GOVERNMENT OF THE DISTRICT OF COLUMBIA
DEPARTMENT OF TRANSPORTATION

MEMORANDUM

SUBJECT: ZC Case No. 15-23 – 10 Van Street, SE

Figure 1 Site Design and Access (Source: Grove/Slade Associates)

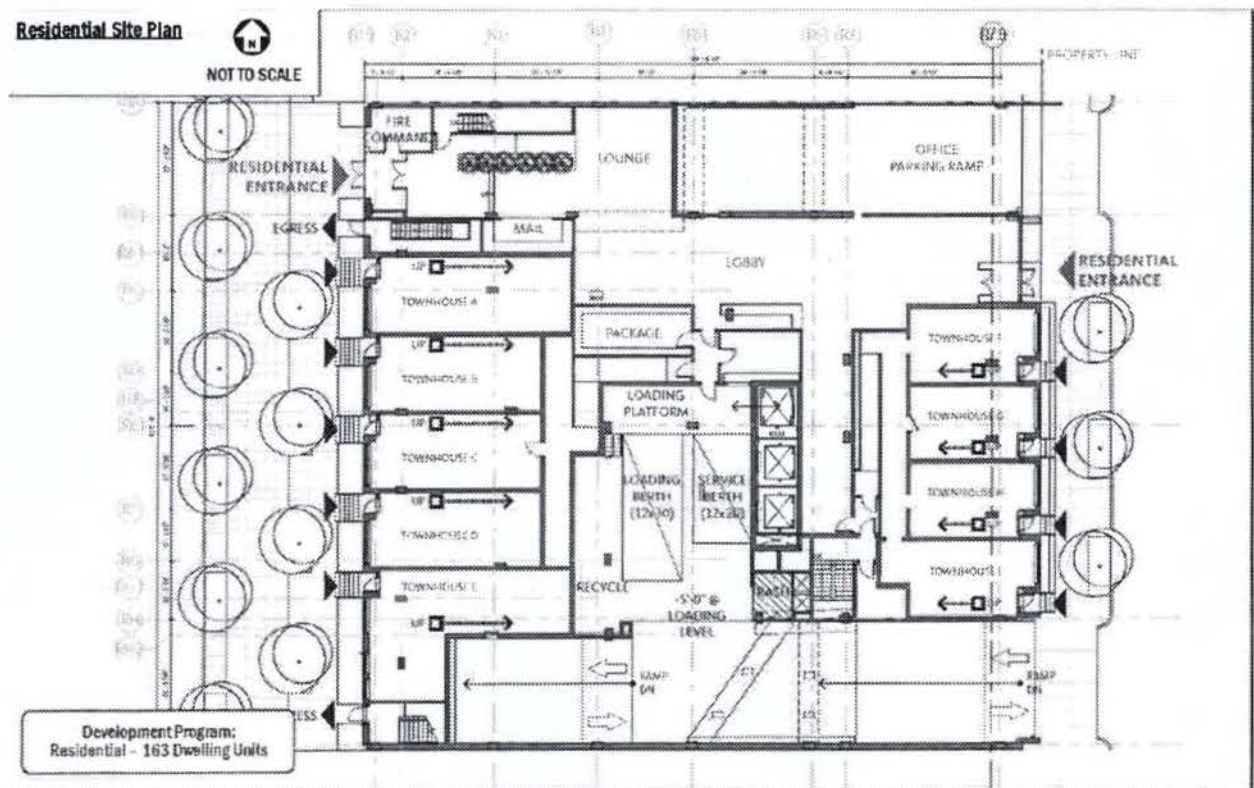
The Applicant proposes all vehicular access to the site on Van Street, which is a short local roadway between Half Street SE and South Capitol Street that connects M and N Streets. As shown in Figure 1, one curb cut is proposed to provide vehicular access, both parking and loading, to the residential building.

DDOT expects the Applicant to design and build the streetscape surrounding the property to current DDOT standards. Various site plans submitted show the property line on Van Street at different locations. DDOT expects to maintain a minimum of an eight-foot (8) clear pedestrian path on Van Street, although 10-foot clearance is preferred. As such, no projections will be permitted through the public space permitting process if they impede on the eight-foot clear path. Additionally, special paving will only be permitted at the primary building entrance to extend one-third the distance from the property line to the curb and not to exceed twice the doorway width, as well as a band around the building of no greater than two-foot width.

Final design of the public space will be determined during DDOT's public space permitting process. DDOT notes the importance of maximizing the width of sidewalks along the perimeter of the site to accommodate pedestrian and bicycle activity.
